Report FL #: 10088 for Greenheck models EHH-601D & ESD-635D (both w/ and w/o VCD-40 Damper)

Report FL #: 10093 for Airolite models SCH601MD & K6746MD (both w/ and w/o VCD-40 Damper)

APPROVAL DOCUMENT: Drawing No. **K6746MD**, titled "K6746MD Louver", sheets 1 through 37 of 37, dated 08/09/2017, prepared by The Airolite Company, signed and sealed by Wayne K. Helmila, P.E. on 08/19/2024 and 09/27/2024, bearing the Miami-Dade County Product Control revision stamp with the Notice of Acceptance number and expiration date by the Miami-Dade County Product Control Section.

PRODUCT REVISED
as complying with the Florida
Building Code
NOA-No. **24-0930.05**
Expiration Date **12/06/2029**

AIROLITE SCHOFIELD, WISCONSIN 54476 715-359-6171	DRAWN BY MES	DATE 8/9/2017
	SCALE	SHEET NO. 5 OF 37
TITLE K6746MD LOUVER FLANGE FRAME SLEEVE MOUNT HEAD & SILL DETAILS H≤144"		
CAD DRAWING NO. K6746MD

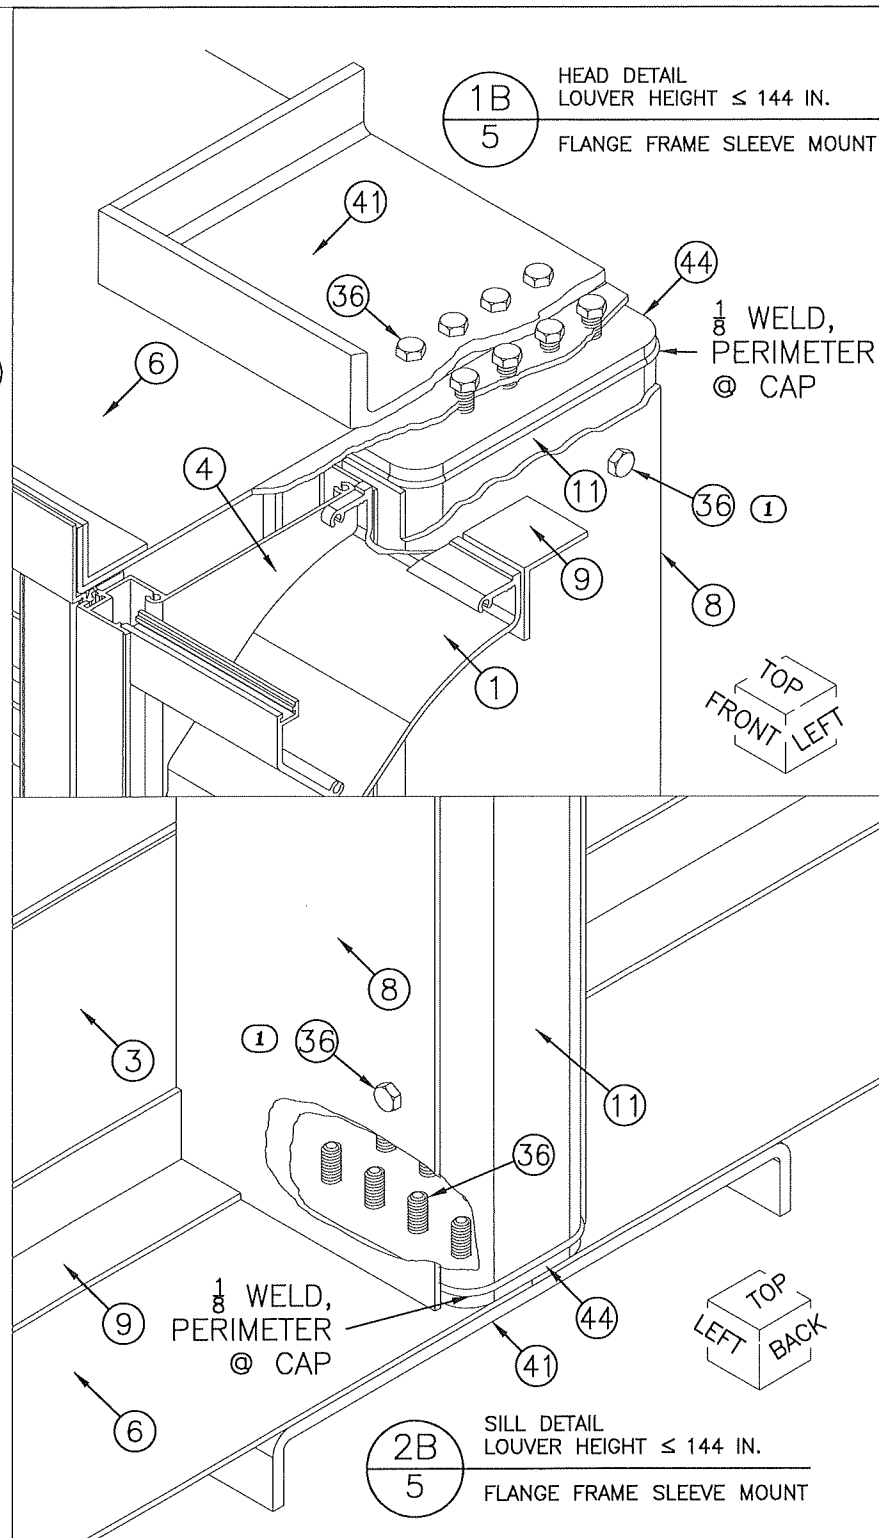
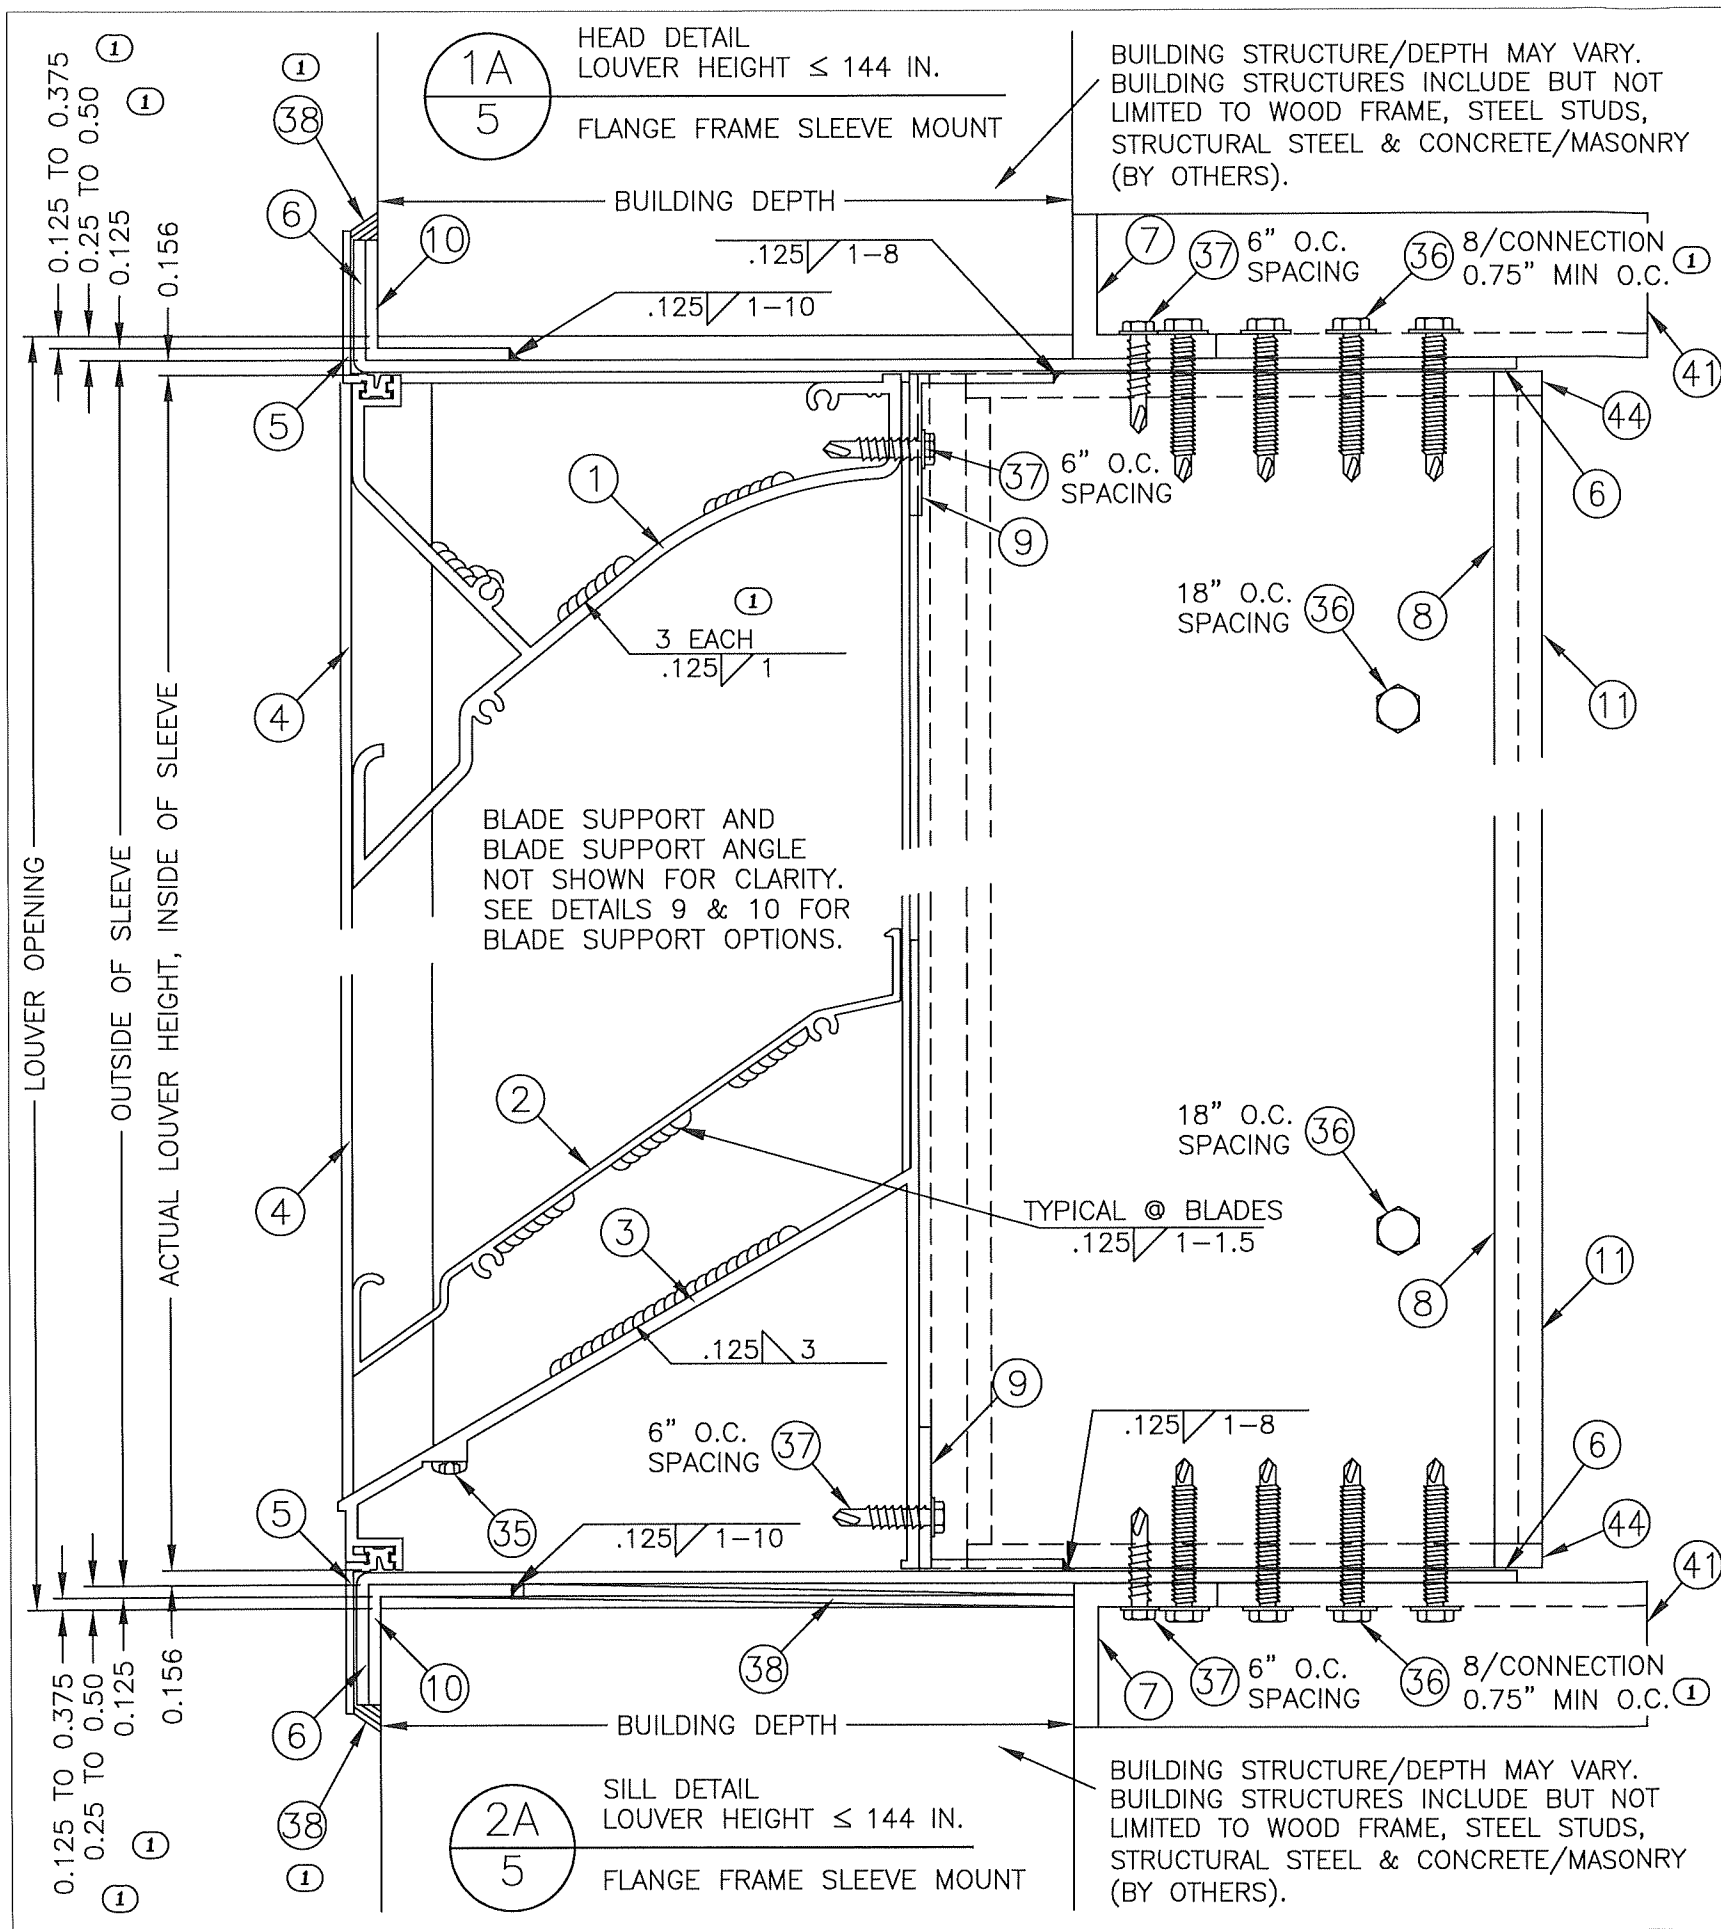
REV 01: 8/1/24, REMOVED "TYP" X4, ADDED ITEM 38 X2, ADDED MIN O.C. FOR ITEM 36 X2, ADDED CALLOUT FOR ITEM 36 X2, REMOVED ITEM 12, & ADDED HEAD WELD CALLOUT.

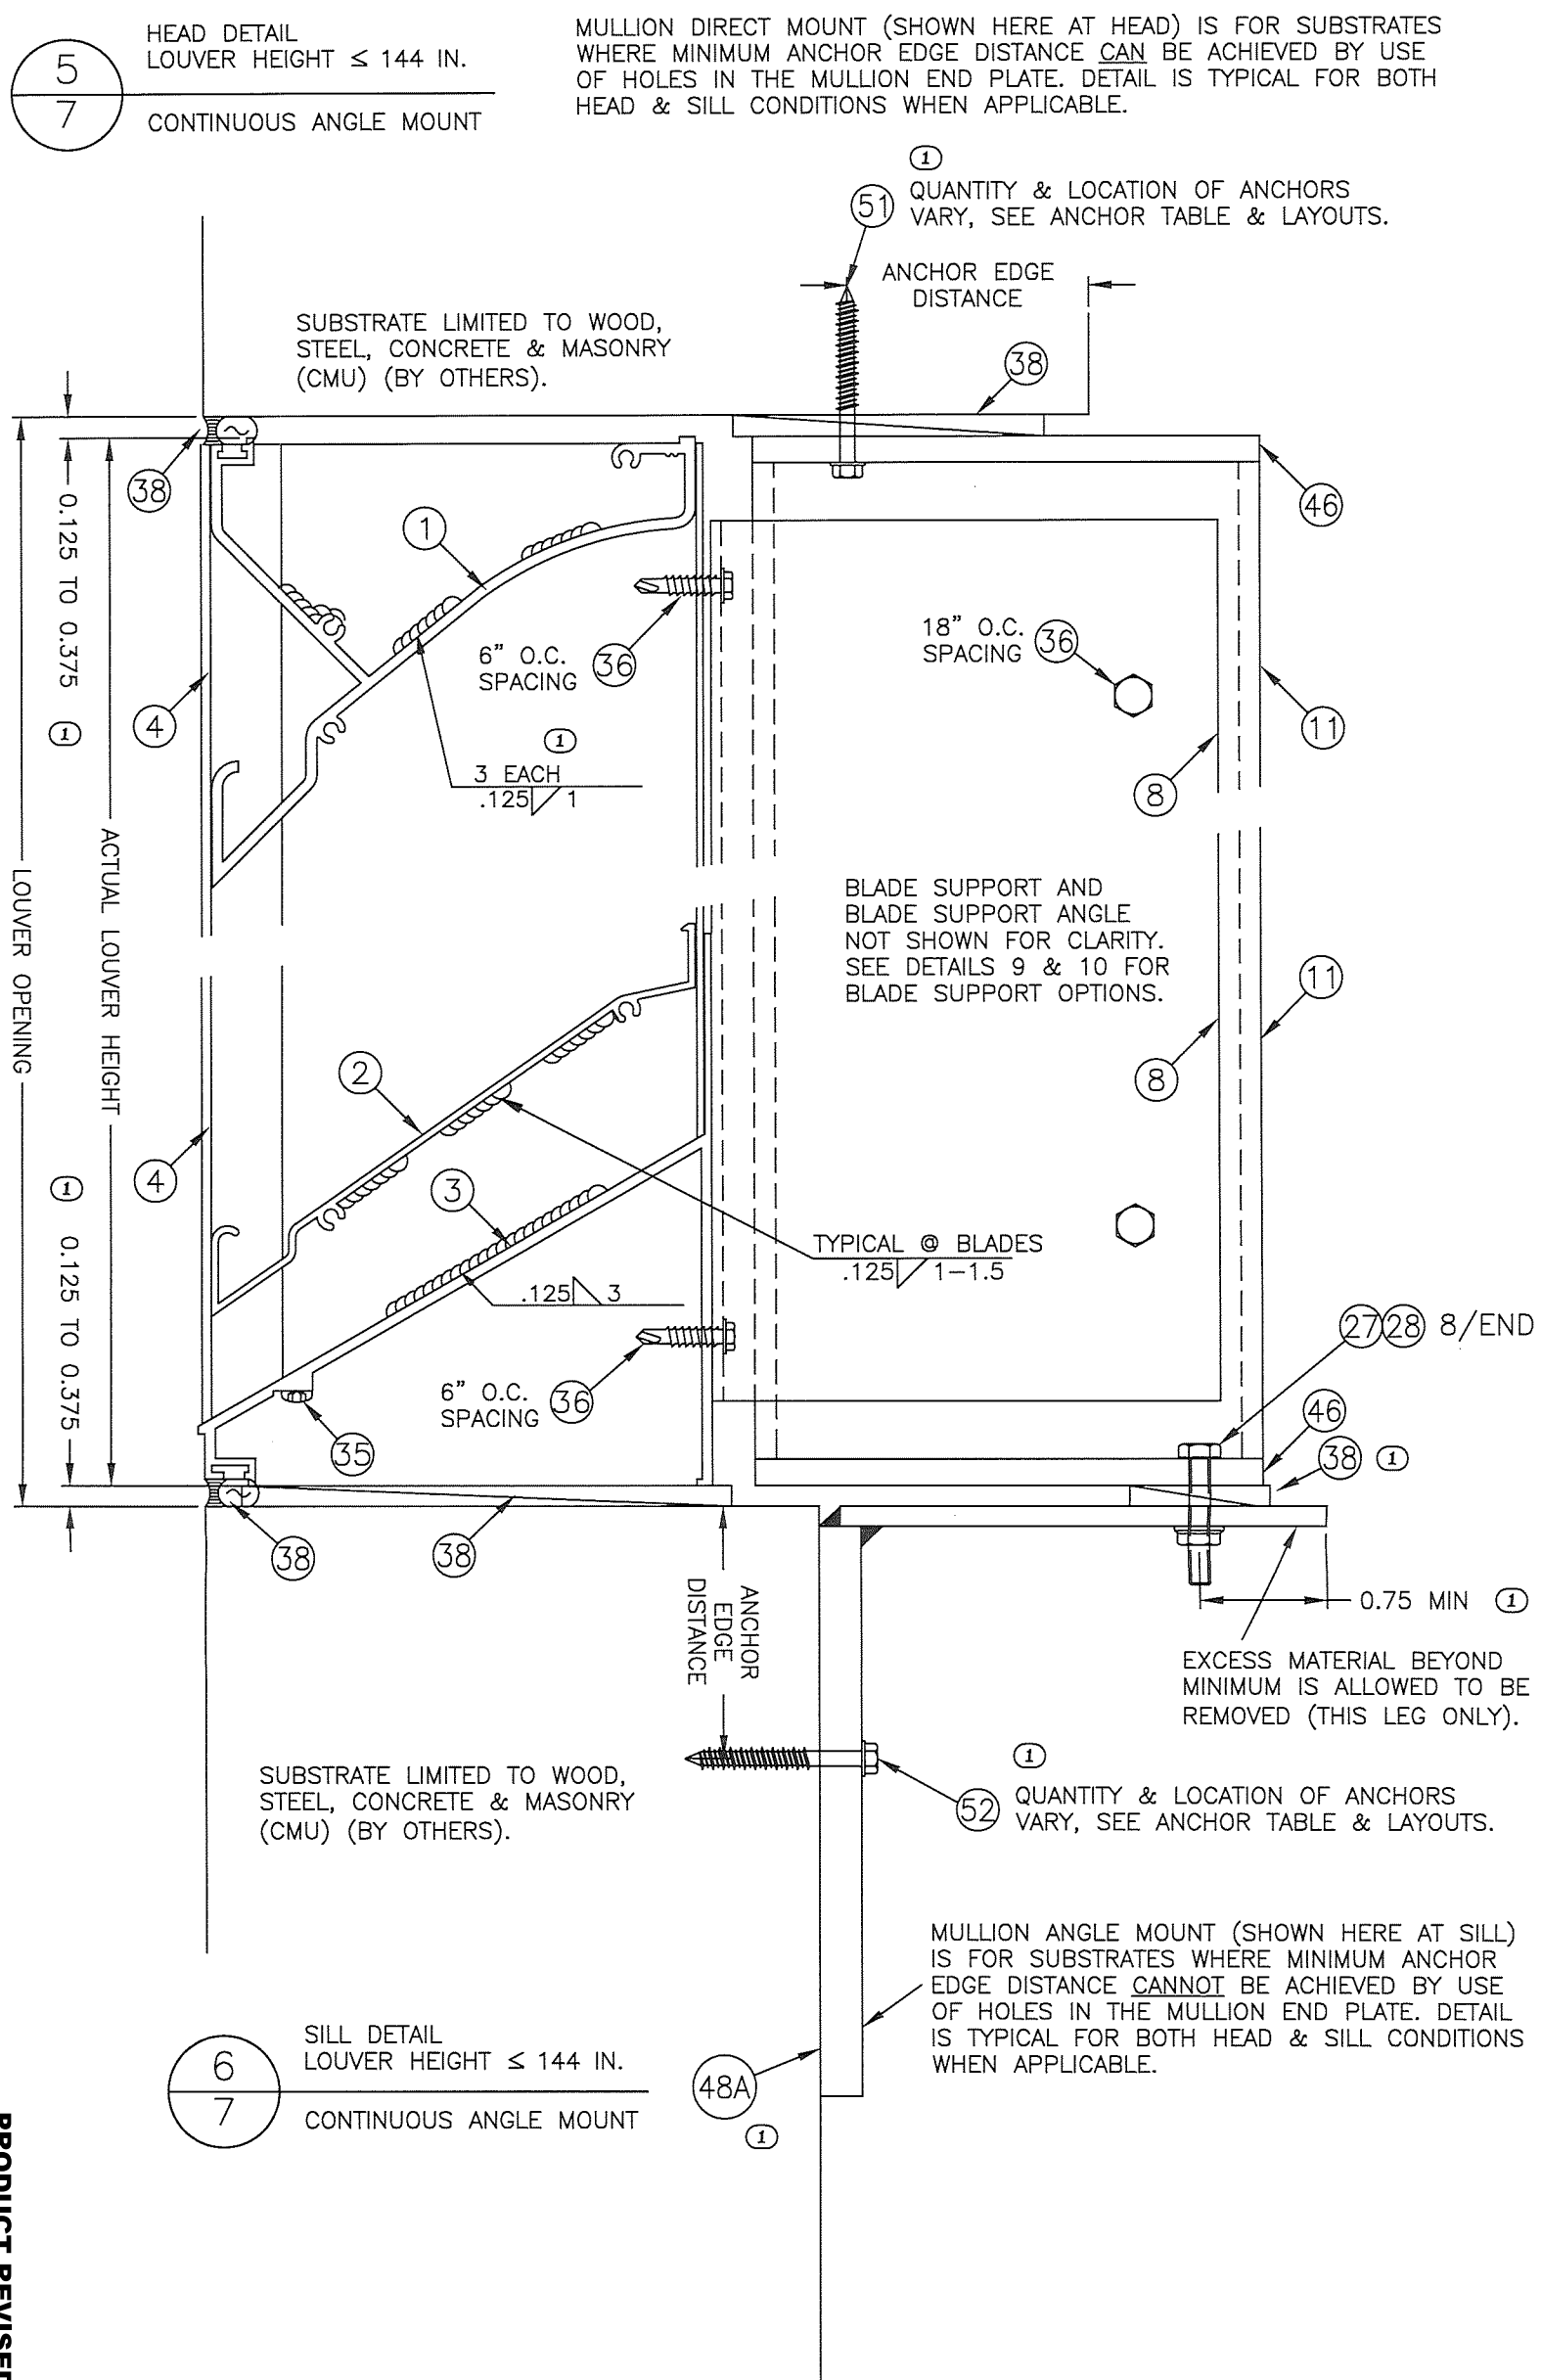
REV 01: 8/1/24, MOVED DETAILS 7 & 8 TO A NEW PAGE, ADDED ITEM 38, ADDED MIN OFFSET, UPDATED ANCHOR NOTE X2, UPDATED ITEM 48 CALLOUT & LAYOUT, ADDED HEAD WELD CALLOUT, & REMOVED "TYP" FROM EDGE GAP X2.
